**Committee of Experts on the Transport of Dangerous Goods
and on the Globally Harmonized System of Classification
and Labelling of Chemicals**

**Use of the Manual of Tests and Criteria in the context of the
GHS**

**Transmitted by the Chairman of the Working Group on Explosives of
the Sub-Committee of Experts on the Transport of Dangerous Goods
(TDG Sub-Committee) on behalf of the Working Group**

SECTION 28

Figure 28.4.3.2: EXAMPLE OF DETERMINATION OF SADT OR SAPT

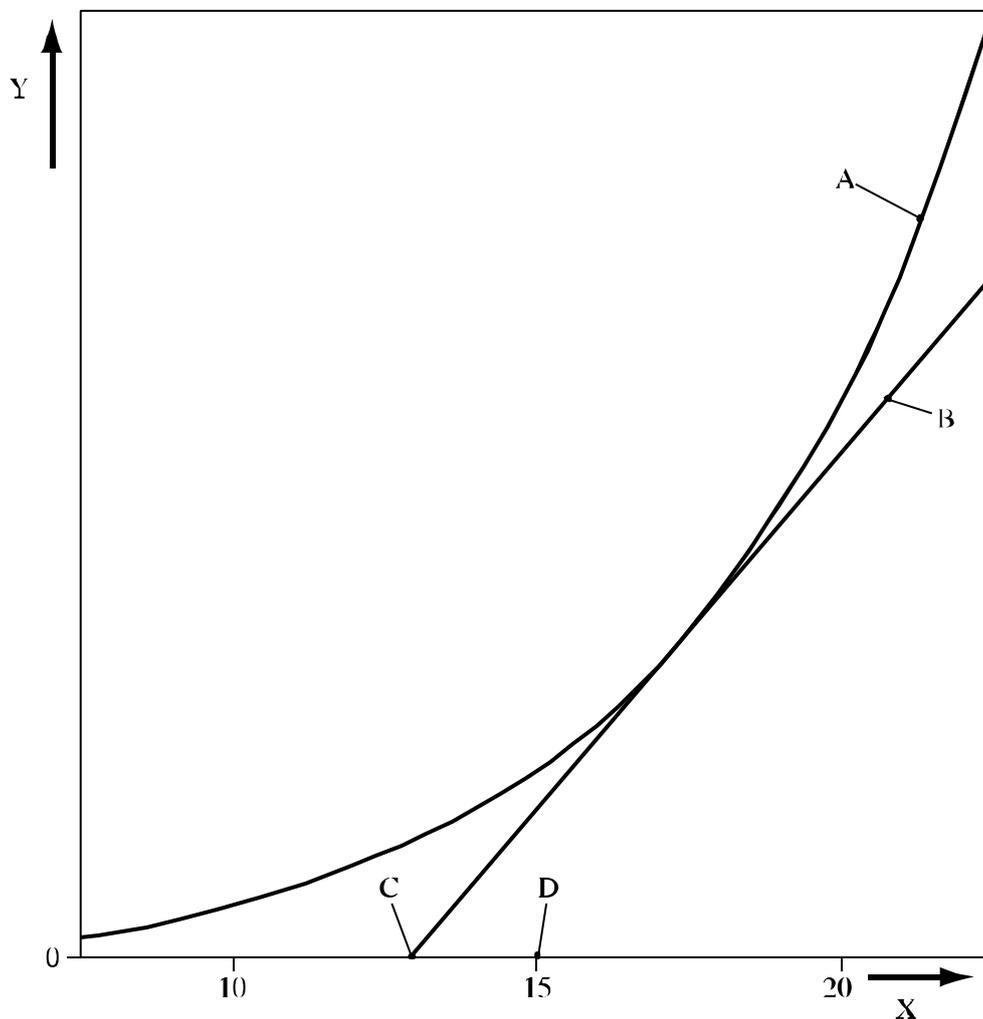
-
- (A) Heat generation curve
 - (B) Line with gradient equal to the rate of heat loss and tangential to the heat generation curve
 - (C) Critical ambient temperature (intercept of heat loss line with the abscissa)
 - (D) ~~Self accelerating decomposition temperature (SADT or SAPT)~~ - critical ambient temperature rounded up to next higher multiple of 5 °C
 - (X) Temperature
 - (Y) Heat flow (generation or loss) per unit mass
-
